Errata Sheet

Product Family:	DL205 / DL305	Date:	September 2018
Manual Number	D2-DCM		
Revision and Date	2nd Edition; February 2003

Page A-4. Point-to-Point RS422 D2–DCM as Master

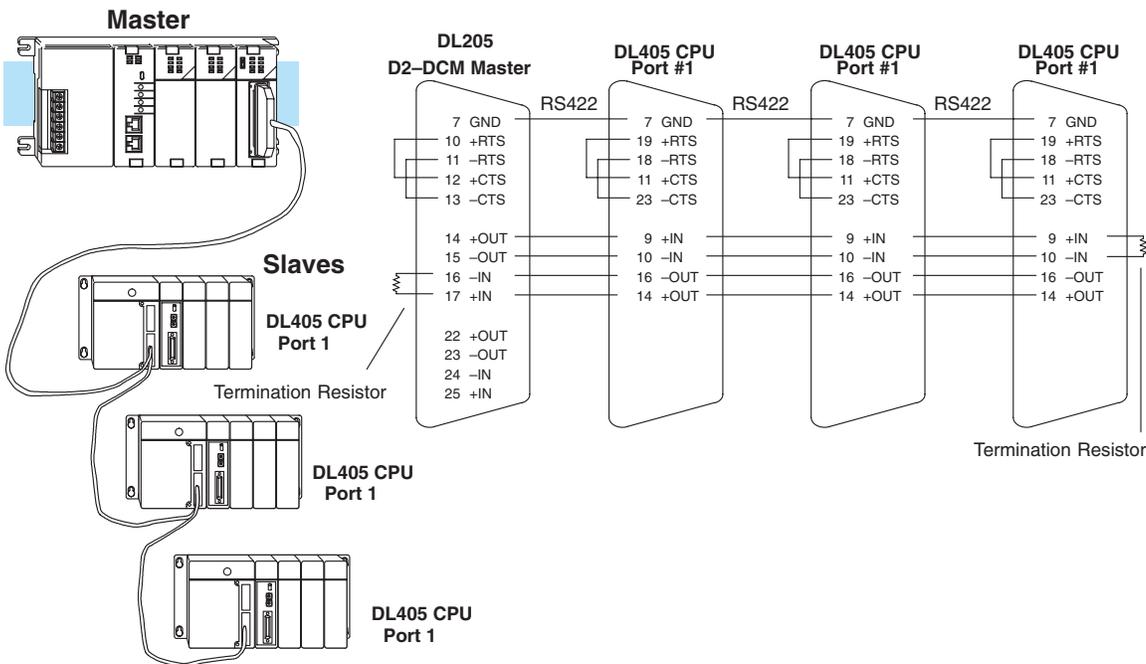
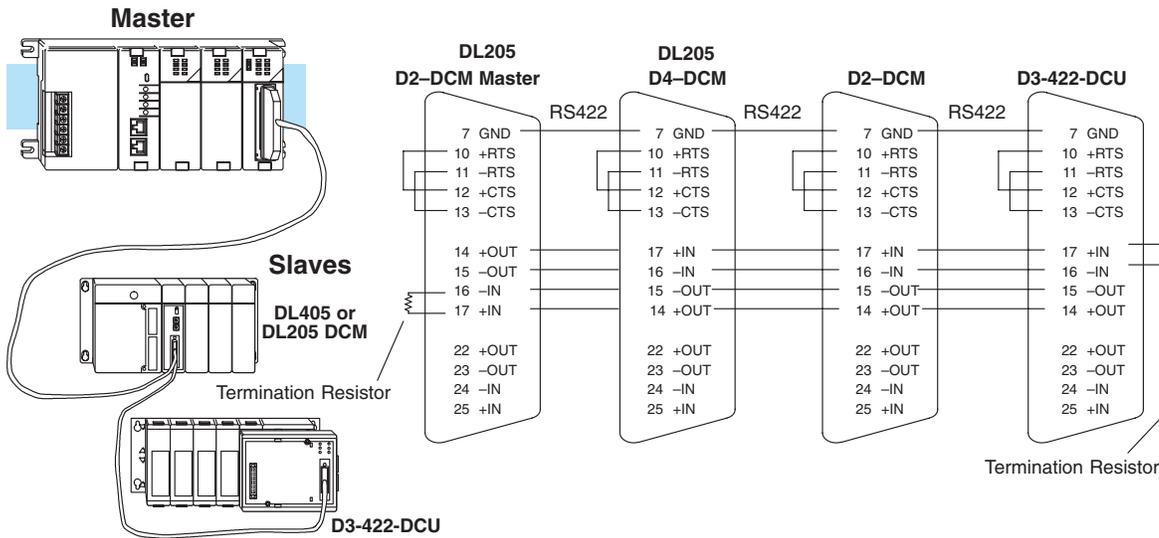
In the lower left drawing there are some pin number errors for the DL405 port 1 25-pin connector. The correct pin numbers are:

19 +RTS (not 10 as shown)

18 -RTS (not 11 as shown)

11 +CTS (not 12 as shown)

23 -CTS (not 13 as shown)

In the top set of drawings, change the callout that says “DL405 CPU Bottom Port” to DL405 Port 1”
